DESCRIPTION OF PROPOSED CHANGES  
NPF-10-50 AND NPF-15-50, REVISION 2<sup>25</sup>  
AND SAFETY ANALYSIS

This is a request to revise Technical Specification 3/4.9.6, REFUELING MACHINE.

DESCRIPTION OF PROPOSED CHANGE NPF-10/15-52 AND  
SAFETY EVALUATION

This is a request to revise Technical Specifications 3.4.2.4 and 3.3.1 (Table 3.3-1, Action 6) and associated bases.

Figure 3.2-2 DNBR margin operating limit based on core protection calculators. (COLSS out of service)

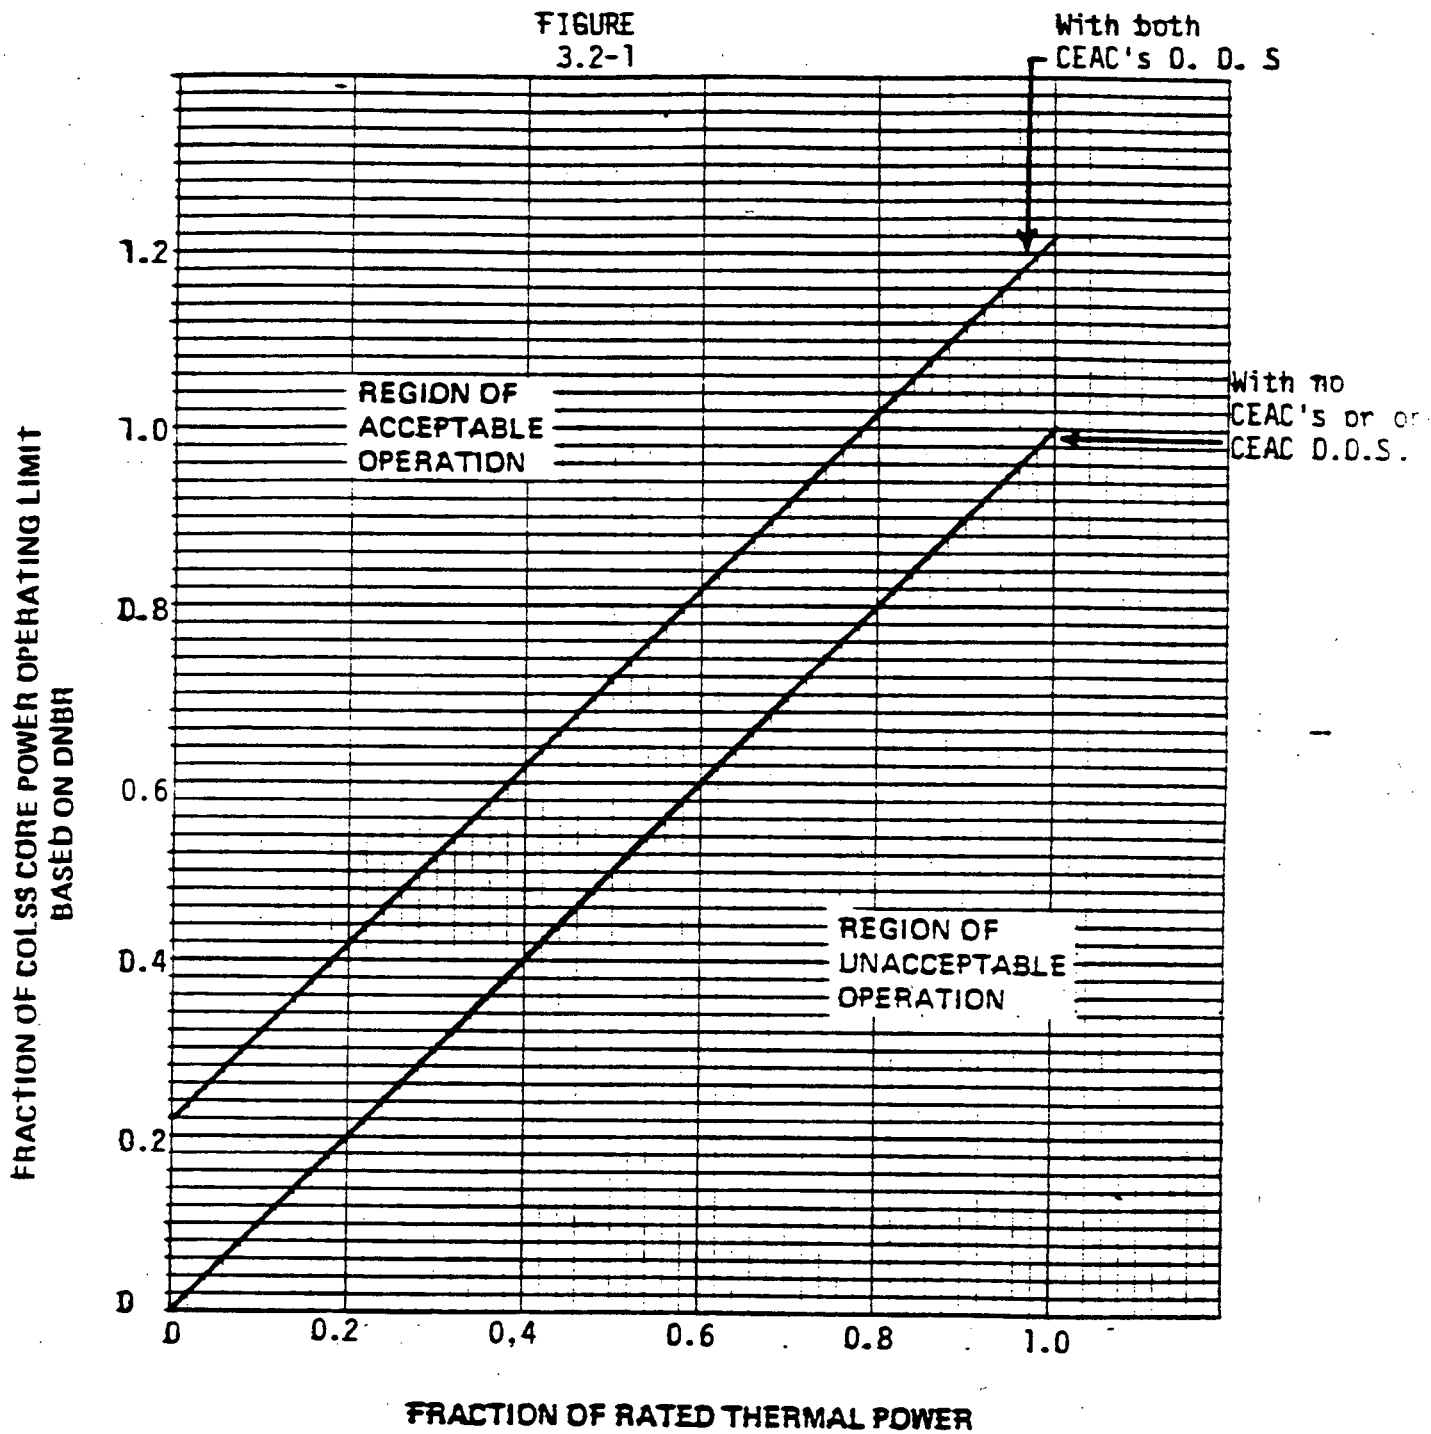
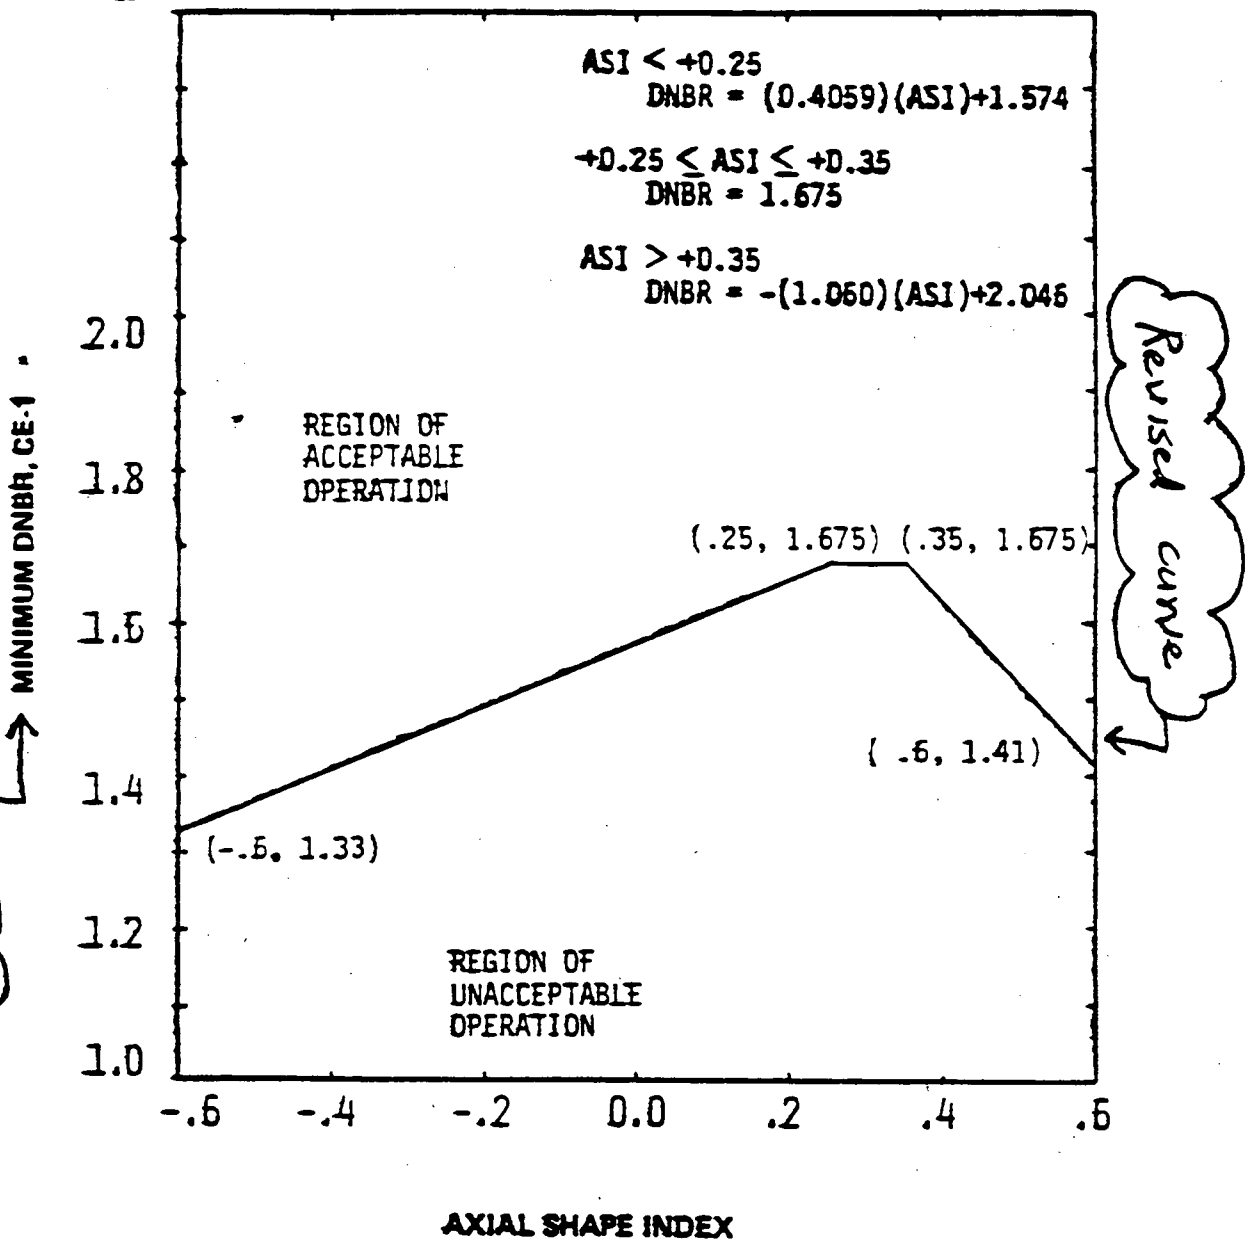
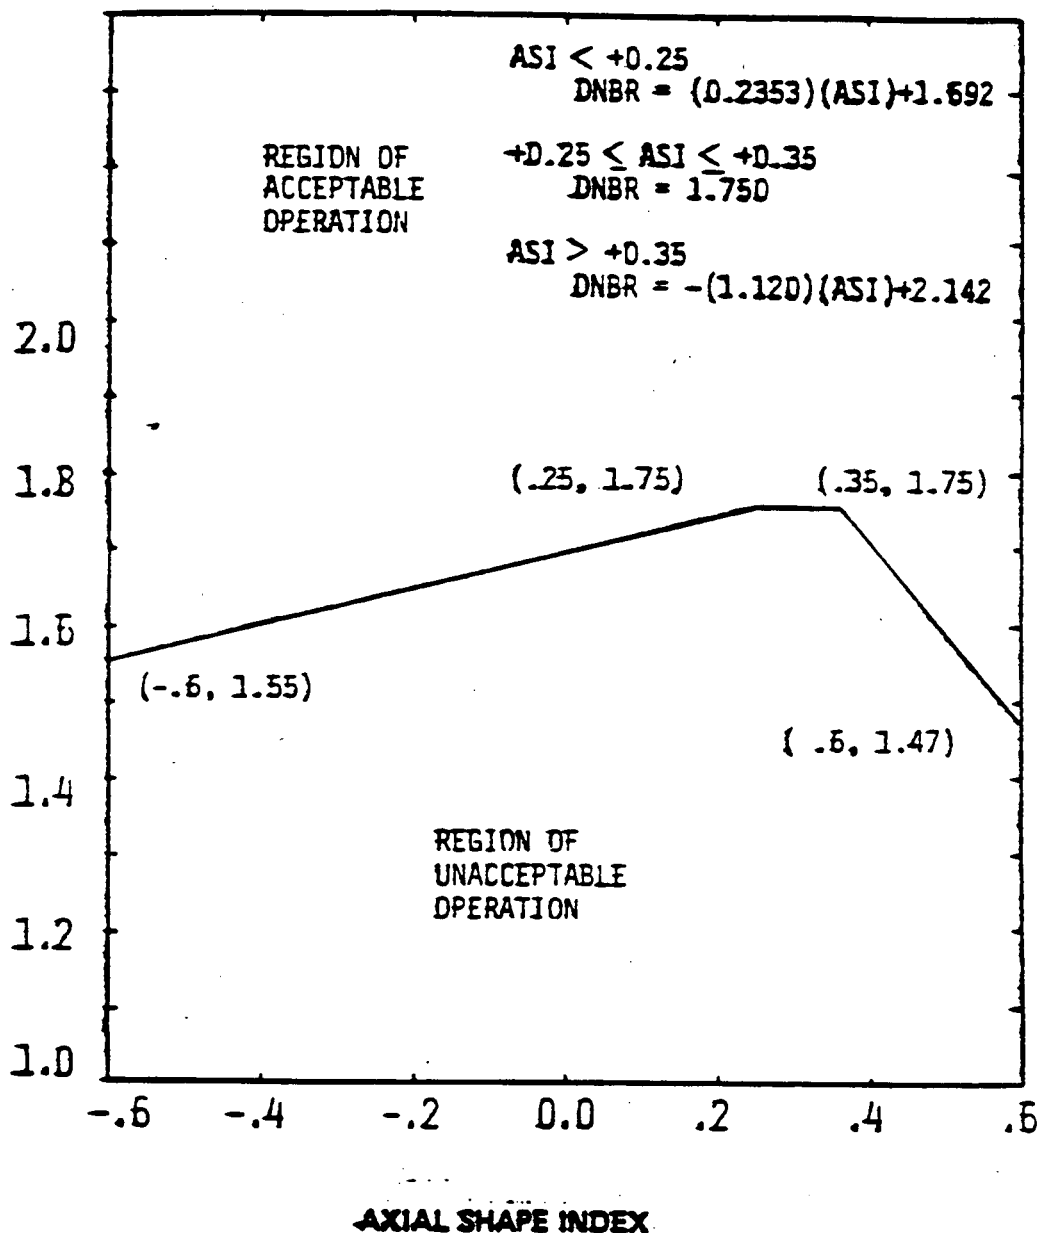
This proposed change increases the COLSS out-of-service margin by 10%. The thermal margin gain is reflected in the new COLSS out-of-service limit lines as presented in revised Figure 3.2-2 and new Figure 3.2-3 of Attachment B. These lines take into account a reevaluated CPC overall uncertainty consistent with the requirements of LCO monitoring.

Add: with RATED THERMAL POWER  $\geq 80\%$ .

change to: 3.2-3

Change to: 3.2-3

Add: with RATED THERMAL POWER < 80%.

Figure 4.4-1  
TUBE WALL THINNING ACCEPTANCE CRITERIA

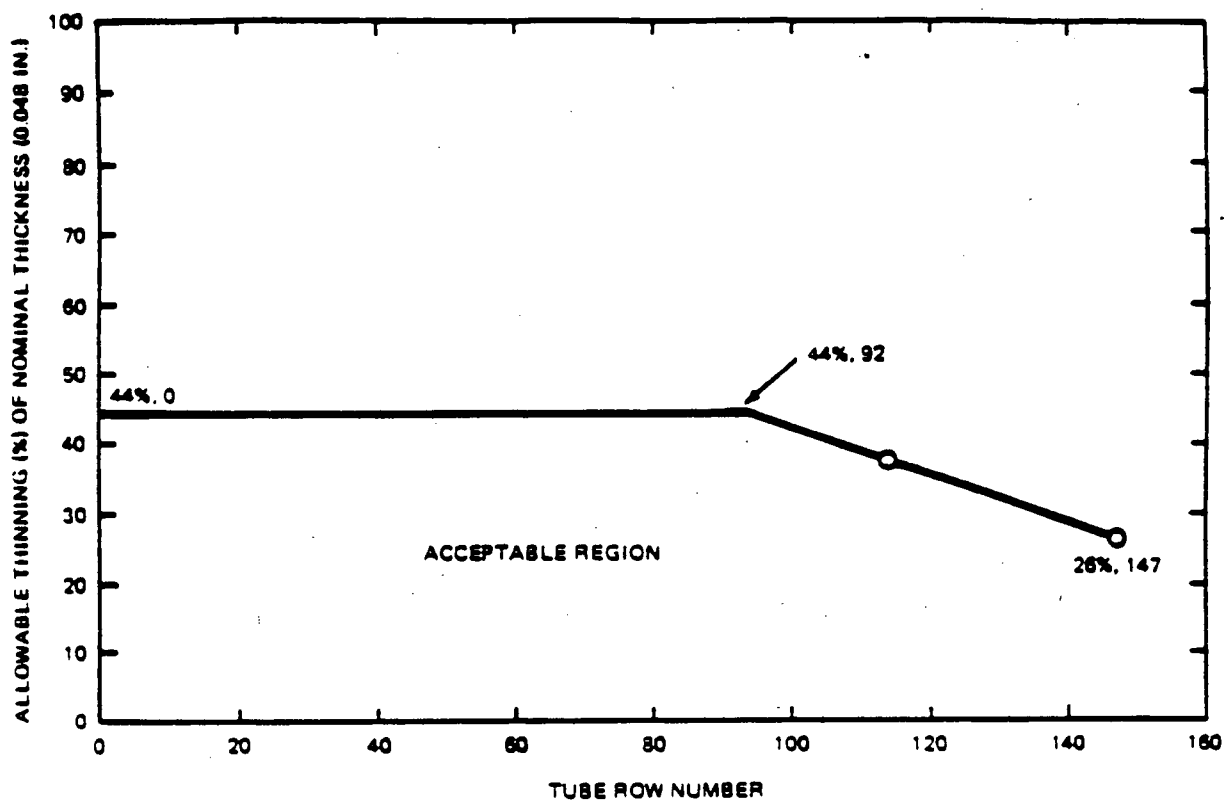
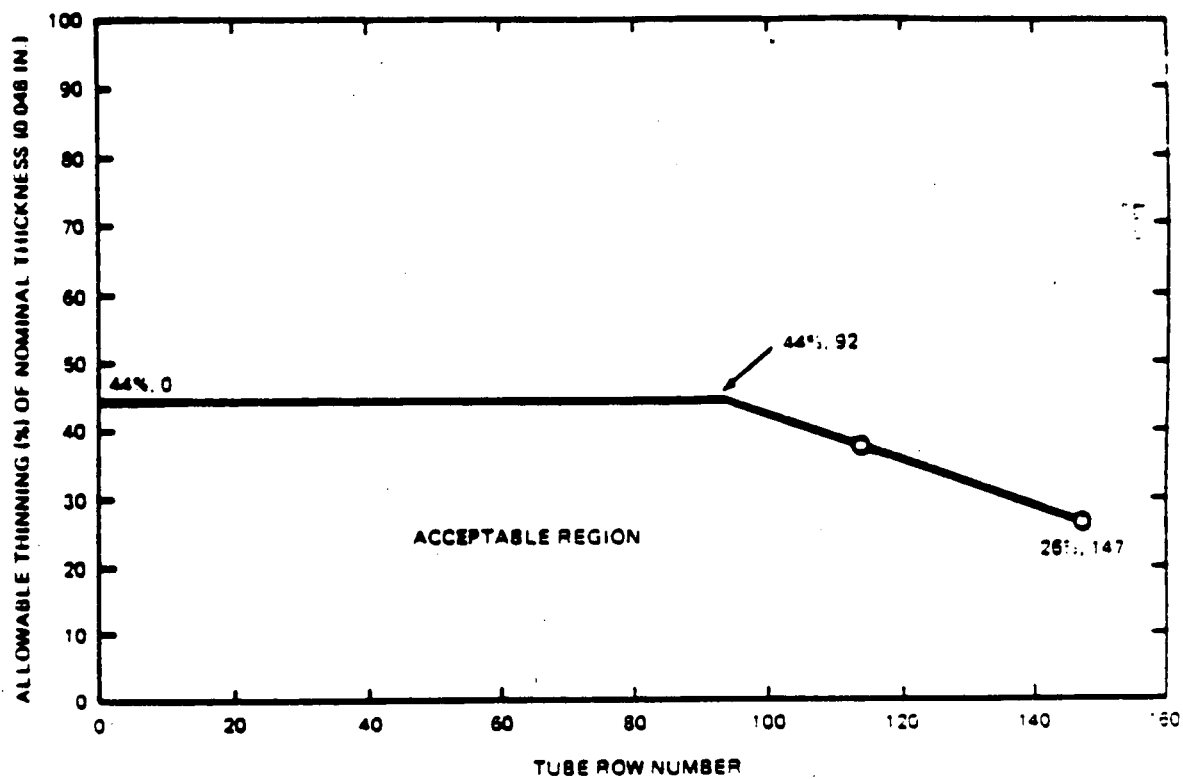
Technical Specification 3/4.4.4 requires steam generator operability and specifies Surveillance Requirements to verify steam generator integrity. the current acceptable level of steam generator tube wall thinning shown in Figure 4.4.1, is 44% for tube rows 0 through 92 and decreases linearly to 26% in tube row 147. The proposed change will delete Figure 4.4.1 and specify a tube thinning limit of 44% for all steam generator tubes.

The revised analysis of the limiting LOCA/SSE scenario credits the frictional or binding restraint on the tubes provided by the vertical tube supports in the horizontal tube run on top of the "U" tube span; this was previously neglected in the original calculations. In addition, the LOCA and SSE peak loads were combined by square-root-of-the-sum-of-the-squares (SRSS) combination; these loads were added in the original calculations. The combination of a LOCA and SSE is still the limiting event. The revised analysis shows that tube degradation of up to 64 percent is acceptable for all steam generator tubes in meeting the criteria of Regulatory Guide 1.121.

In establishing the Technical Specification limits for San Onofre Units 2 and 3, the NRC imposed a 20 percent reduction in the above allowable degradation to cover Eddy Current Testing (ECT) measurement error and continued degradation through the next fuel cycle (in response to guidance provided in Regulatory Guide 1.121). As a result, a steam generator tube degradation limit of 44 percent for all steam generator tubes is proposed.
